UNITED STATES PATENT AND TRADEMARK OFFICE

APPLICATION NO.	FILING DATE	FIRST NAMED INVENTOR	ATTORNEY DOCKET NO.	CONFIRMATION NO.
10/694,304	10/27/2003	David M. Allen	DMA-10002/36	3573
25006	7590	06/02/2006	EXAMINER	
GIFFORD, KRASS, GROH, SPRINKLE & CITKOWSKI, P.C				GILBERT, WILLIAM V
PO BOX 7021				
TROY, MI 48007-7021				
ART UNIT		PAPER NUMBER		
		3635

Office Action Summary	Application No.	Applicant(s)	
	10/694,304	ALLEN, DAVID M.	
	Examiner	Art Unit	
	William V. Gilbert	3635

Figure 3 from Carter

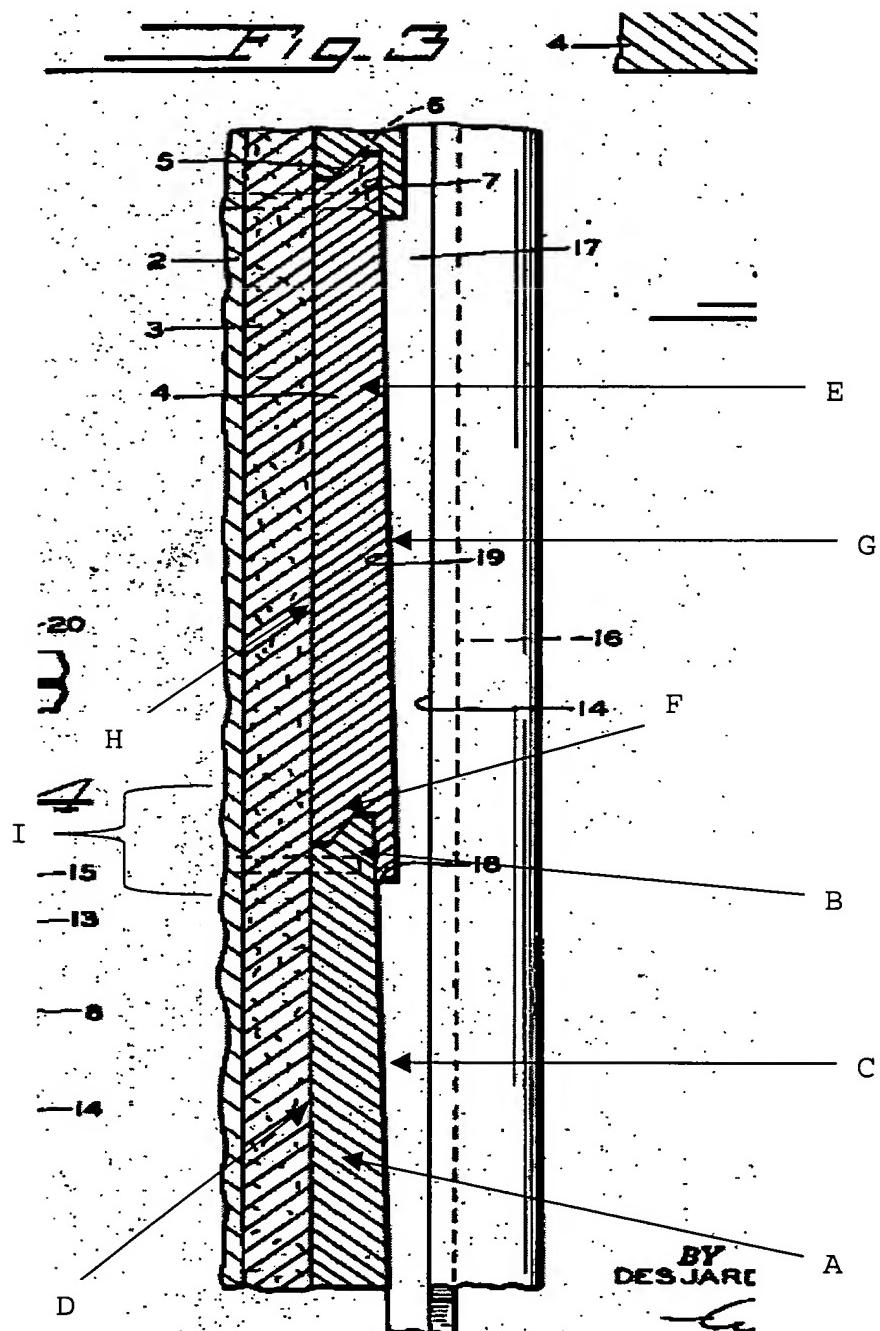
3. Regarding Claim 1, Carter discloses an assembly (4) having a base portion (see element "A" of attached Figure 3 from Carter, *infra*), where the upper end (see element "B" of attached Figure 3 from Carter, *infra*) being sloped downwardly from the front surface (see element "C" of attached Figure 3 from Carter, *infra*) to the back surface (see element "D" of attached Figure 3 from Carter, *infra*), and a top portion (see element "E" from attached Figure 3 from Carter, *infra*), where the lower end (see element "F" from attached Figure 3 from Carter, *infra*) of the top portion being sloped downwardly from the front surface (see element "G" from attached Figure 3 from Carter, *infra*) to the

back surface (see element "H" from attached Figure 3 from Carter, infra.)

5. Regarding Claim 4, Carter discloses the base portion (A, supra) and top portion (E, supra) each having a generally rectangular horizontal cross section (Figure 3, generally; see also Claim objection, supra).

6. Regarding Claim 5, Carter discloses the upper end of the base portion (B, supra) having a sloped surface that forms an angle with the front surface (C, supra) of the base portion and the lower end of the top portion (F, supra) comprises a sloped surface that forms substantially the same angle with the back surface of the top portion (H, supra). See area "I" from attached Figure 3 from Carter, supra.

and H respectively) and front surfaces (C and G respectively) being substantially the same (Figure 3, generally).

Figure 7 from Hasenwinkle

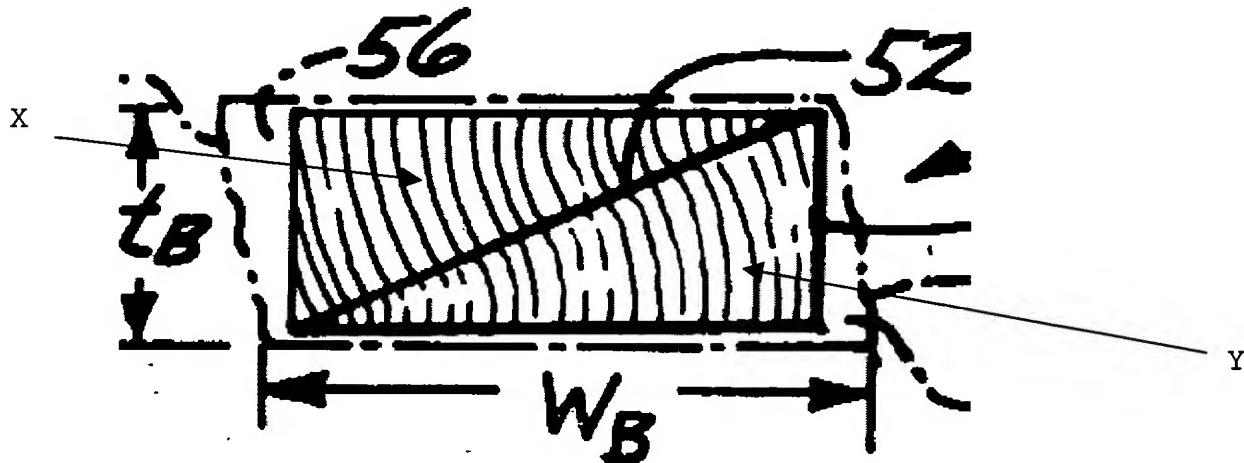
Regarding Claim 13, Carter discloses providing a board (4) having a front surface (C, *supra*) and an opposed back surface (D, *supra*) and discloses cutting the board lengthwise at a non-perpendicular angle (see Figure 3, generally), but Carter does not disclose the board's forming the base portion and the top portion when cut. Hasenwinkle discloses cutting wood at non-perpendicular angles (see Hasenwinkle Figure 5, element 36) to form a top portion (see element "X" of attached Figure 7 from Hasenwinkle, *infra*; see also Column 1, lines 5-10) and a bottom portion (see element "Y" from attached Figure 7 from Hasenwinkle, *infra*.) It would have been obvious at the time the invention was made to a person having ordinary skill to cut the board at non-perpendicular angles as in Carter to form the base portion and top portion as shown in Hasenwinkle. One would have been motivated to make such a modification because cutting a board lengthwise to form a top and bottom portion would be more economically practical as opposed to forming a base portion by cutting one piece of wood and forming a top portion by cutting a separate piece of wood.
